UNITED STATES DEPARTMENT OF COMMERCE
Patent and Trademark Office

APPLICATION NO.	FILING DATE	FIRST NAMED INVENTOR	ATTORNEY DOCKET NO.
09/473,315	12/28/99	MOSLEY	L 884.209US1

Office Action Summary

DETAILED ACTION

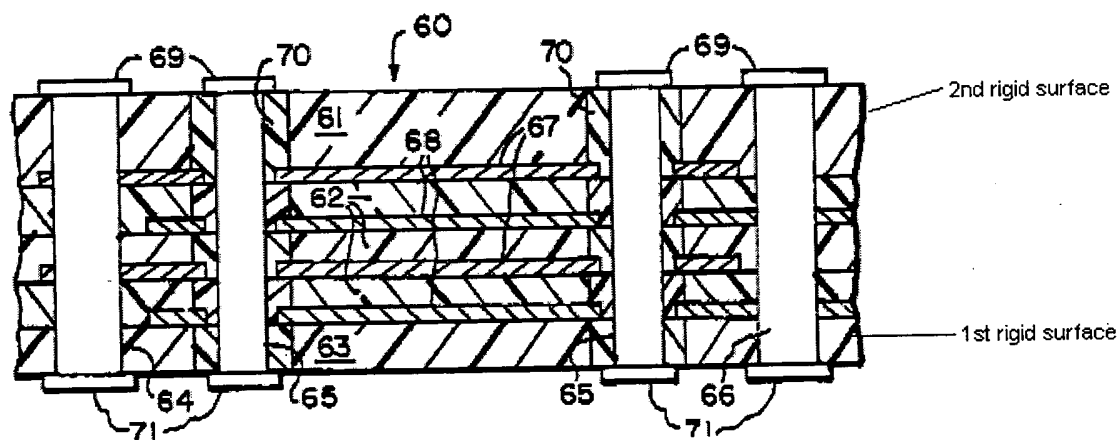
Regarding claim 9, Farooq et al. disclose in fig. 3 A, a multilayer capacitor having a pair of substantially rigid outer surfaces (see below), and a number of pads (69) located on two of the number of outer surfaces; wherein two of the number of pads are capable of being coupled to a substrate using a solder bump.

Regarding claim 10, the multilayer capacitor includes a number of parallel

conductive layers and the number of pads are coupled to the number of parallel conductive layers through vias.

FIG. 3B

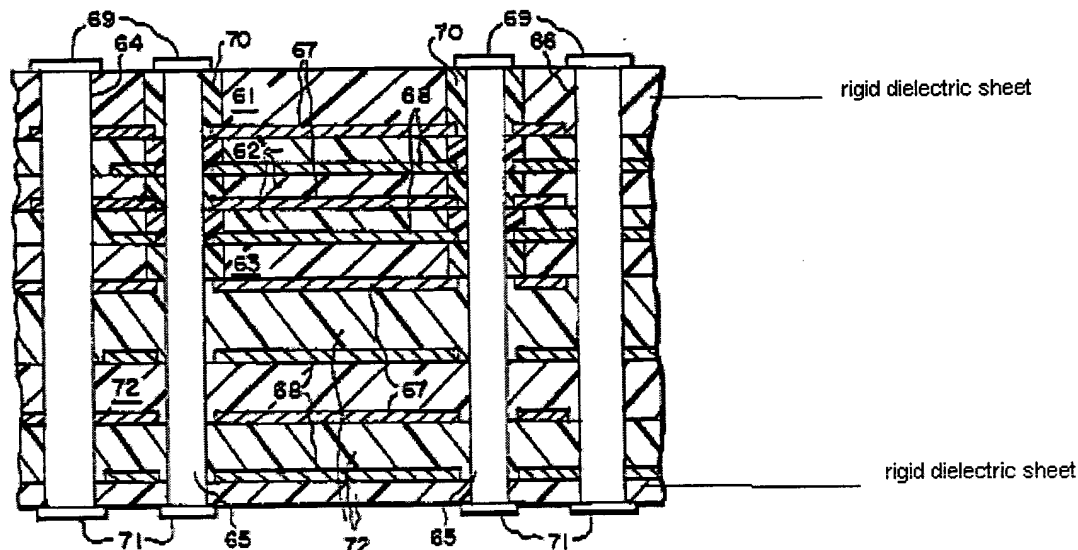
Regarding claim 6, Farooq et al. disclose (in fig. 3c) a plurality of first conductive layers (67), each of the plurality of first conductive layers formed on a first dielectric sheet (72); a plurality of second conductive layers, each of the plurality of second conductive layers formed on a second dielectric sheet (72), and the plurality of second conductive layers interlaced with the plurality of first conductive layers; a pair of dielectric sheets (see below) having a thickness, for providing a pair of substantially rigid outer surfaces for the plurality of second conductive layers interlaced with the plurality of first conductive layers, each of the pair of substantially rigid outer surfaces having a plurality of connection sites operable for coupling the capacitor to a substrate using a controlled collapse chop connection (C4); and a plurality of vias (64, 66) coupling the plurality of first conductive layers and the plurality of second plurality of second conductive layers to at least two of the plurality of connection sites.

Farooq et al. do not disclose the thickness of the pair of dielectric sheets having a thickness of slightly greater than 7 microns. It would have been an obvious matter of design choice to form the pair of dielectric sheets having a thickness of slightly greater than 7 microns, since such a modification would have involved a mere change in the size of a component. A change in size is generally recognized as being within the level of ordinary skill in the art. *In re. Rose*, 105 USPQ 237 (CCPA 1955).

FIG. 1

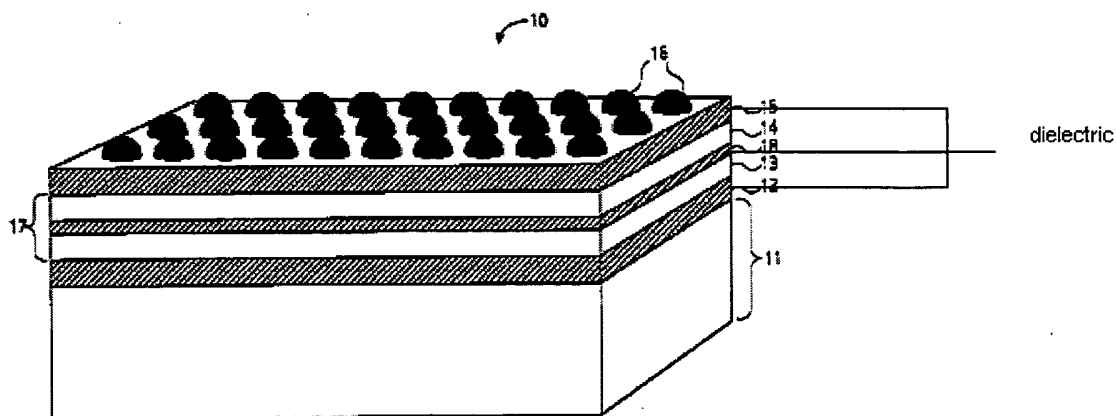
Regarding claim 1, Herrell et al. disclose in fig. 1, a plurality of conductive layers (13-14), embedded in a dielectric (12, 15, 18); and a plurality of vias (see fig. 3A-3B) coupling two conductive layers to a plurality of connection sites (16).

-The argument (pg. 4 first paragraph), "that reference number "12" is not described in Harrell et al., so conductive layer 13 is not embedded in a dielectric. Thus, only conductive layer 14 is embedded in a dielectric, and therefore Harrell et al. does not disclose "a plurality of conductive layers embedded in a dielectric"" is not persuasive. Element 12 in fig. 1 is a dielectric (as noted by the cross-hatching). See MPEP 608.02. Therefore, Harrell et al. does anticipate claim 1.
